Stage 1 Road Safety Audit

Castleconnell Flood Relief Scheme

On behalf of OPW / Limerick City & County Council

July 2024

3.2.9 Carriageway Flooding

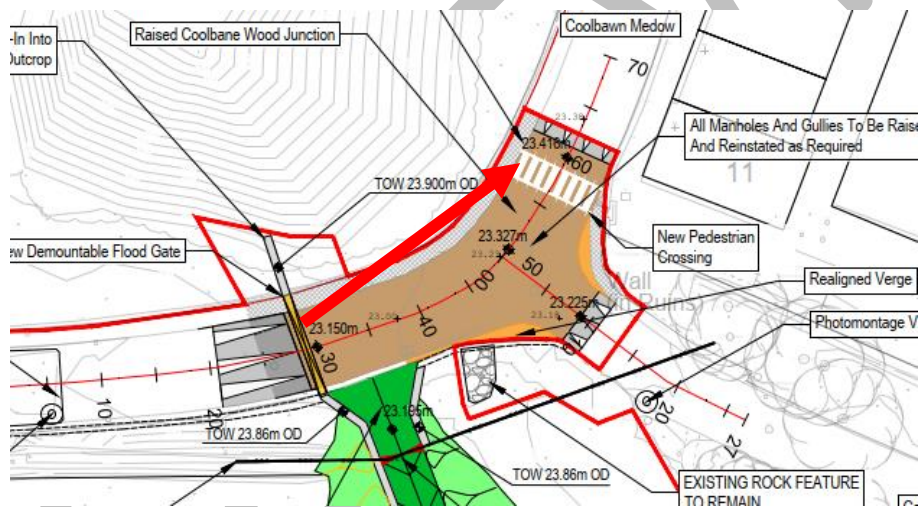
Problem: Further to 3.3.5 above, drivers may inadvertently drive into flood water when approaching from the low side of the flood gate.

Hazard: The vehicle may become stranded on the flooded road. Occupants may be at risk from flood water.

Recommendation: The Design Team should ensure that any signage/traffic management provided when the flood gate is erected, is sufficiently in advance to prevent drivers proceeding into the area liable to flooding.

3.3.2 Zebra Crossing South of Scanlon Park

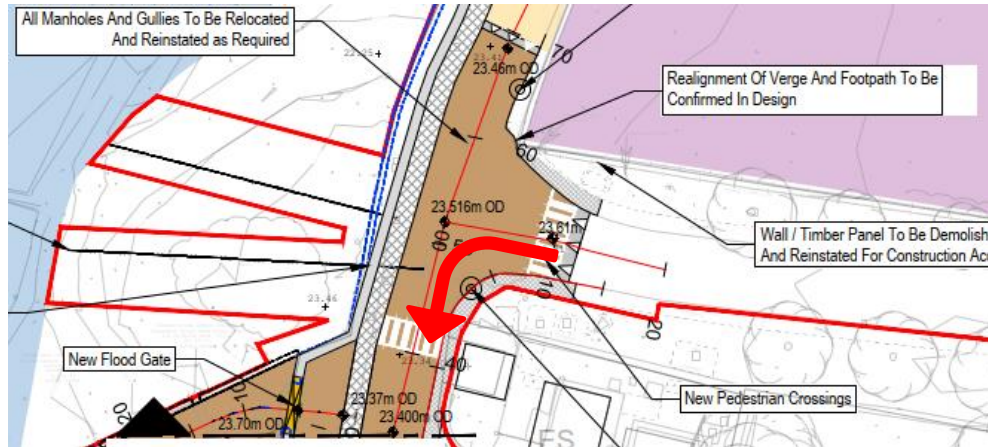
Problem: The proposed zebra crossing is in very close proximity to Scanlon Park. Motorists exiting Scanlon Park and turning left are likely to be concentrating on traffic approaching from their right.

Hazard: On observing no approaching traffic they may proceed out of the side road and impact with pedestrians on the crossing.

Recommendation: The Design Team should relocate the zebra crossing further to the south.

3.3.3 Zebra Crossing of Scanlon Park Road

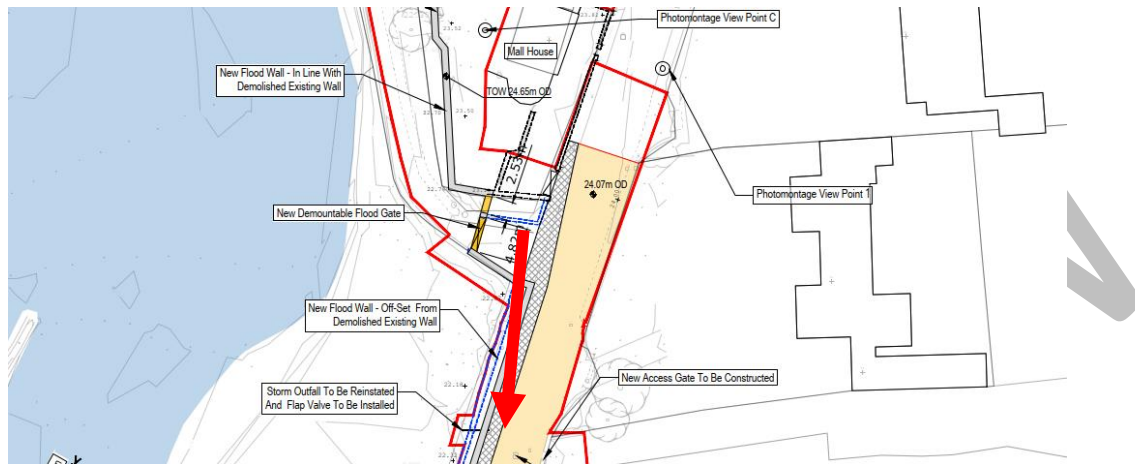
Problem: There is a proposed zebra crossing within Scanlon Park and close to the road junction with Mall Road. There is no footpath further north on Mall Road, therefore all pedestrian demand for this crossing is believed to generate from the houses within Scanlon Park. Pedestrians using this crossing are likely to be unsighted by drivers who turn off Mall Road into Scanlon Park. There is no footpath further north on Mall Road, therefore all pedestrian demand for this crossing is believed to generate from the houses within Scanlon Park.

Hazard: Vehicles may collide with pedestrians on the crossing.

Recommendation: The Design Team should relocate the zebra crossing further distant from the junction with Mall.
